# Access Compliance Report

## Public Rights-of-Way

Intersection ID: 11266	Main Street: AXAR_RD	Cross Street: MULBERRY_CHURCH_RD	Location: NW
ADA ID: 0AAEDE499982	Ramp Type: Perp	Initial Pass/Fail: Fail	Overall Compliance: No
			Severity Score: 21.25

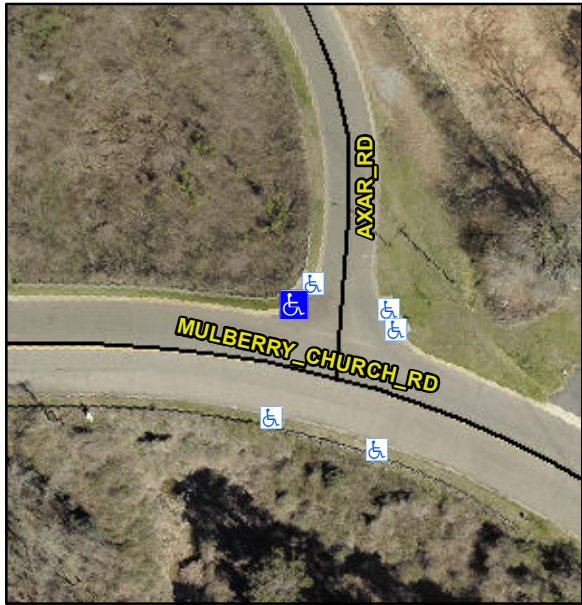
Codes/Mitigation Info/Possible Solution			Field Measurements/Component Compliance					
	Possible Solutions:		Compliance	Description	Data	Compliance	Description	Data
	Remove & Replace Entire Ramp.		N/A	Ramp Length (in)	67.0	No	Ramp Slope (%)	8.8
			No	Ramp Width (in)	42.0	Yes	Ramp XSlope (%)	0.1
			N/A	Flare Type LT	N/A	N/A	Flare Type RT	N/A
			N/A	Flare Slope LT (%)	N/A	N/A	Flare Slope RT (%)	N/A
			N/A	Flare Traversable LT?	N/A	N/A	Flare Traversable RT?	N/A
			N/A	Landing Length (in)	N/A	N/A	DWS Provided?	N/A
			N/A	Landing Width (in)	N/A	N/A	DWS Contrast?	N/A
			N/A	Landing Slope (%)	N/A	N/A	DWS Length (in)	N/A
			N/A	Landing X Slope (%)	N/A	N/A	DWS Full Width?	N/A
Surveyor Notes:	N/A		N/A	Landing Curb? (Y/N)	N/A	N/A	DWS Offset (in)	N/A
			N/A	Shared Landing?	N/A			
	PROW/ADA:		N/A	Gutter Ponding?	N/A	N/A	Gutter Slope (%)	N/A
	Not Found, R304.5.1, R304.2.2		N/A	Gutter Lip Ht (in)	N/A	N/A	Gutter X Slope (%)	N/A
